SUBJECT: Invitation for Bid #10-0547-OV  
10 MG Reclaimed Water Storage Tank at the Southwest  
Water Reclamation Facility \*6036082)

## ADDENDUM #1

Subject: **Text for Addendum No. 1  
IFB 10-0547-OV 10MG Reclaimed Water Storage Tank at the Southwest  
Water Reclamation Facility (6036082)**

PROJECT NO 12008554
DESIGN/APVD TRS/DAW
DATE 12/29/09
FIGURE NO 1

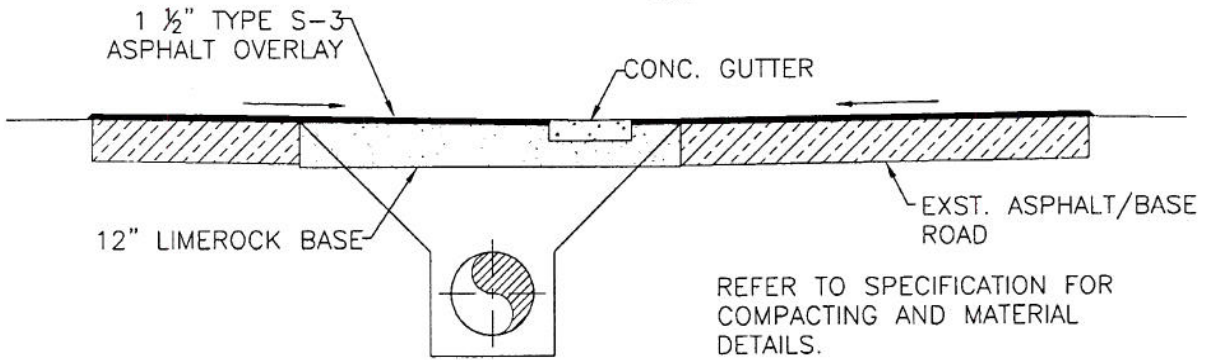
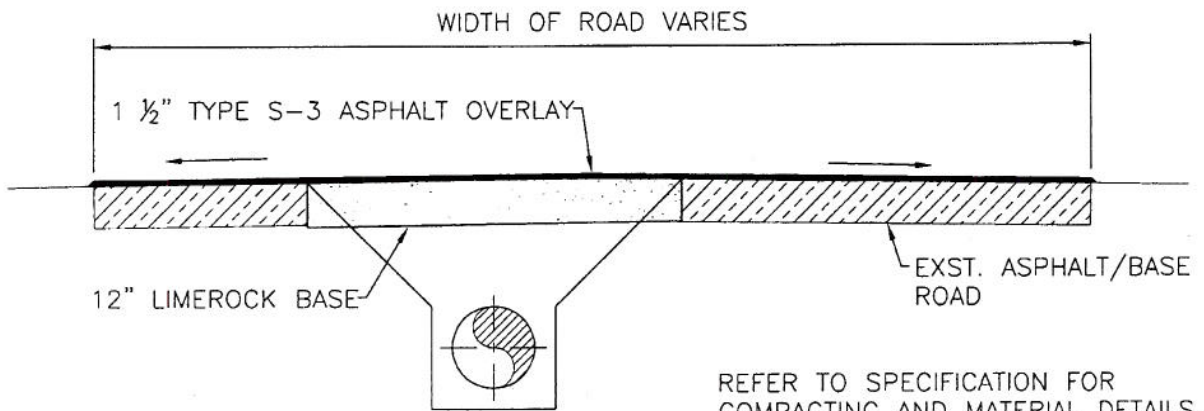
Sheet C-9, Civil Details, Detail UG-12, Trench with Asphalt Pavement Surface Type A-1 Bedding  
Replace asphalt repair portion of Detail UG-12 with the asphalt repair details in attached Figure 1.

## INVERTED CROWN ROAD REPAIR DETAIL

## CROWN ROAD REPAIR DETAIL
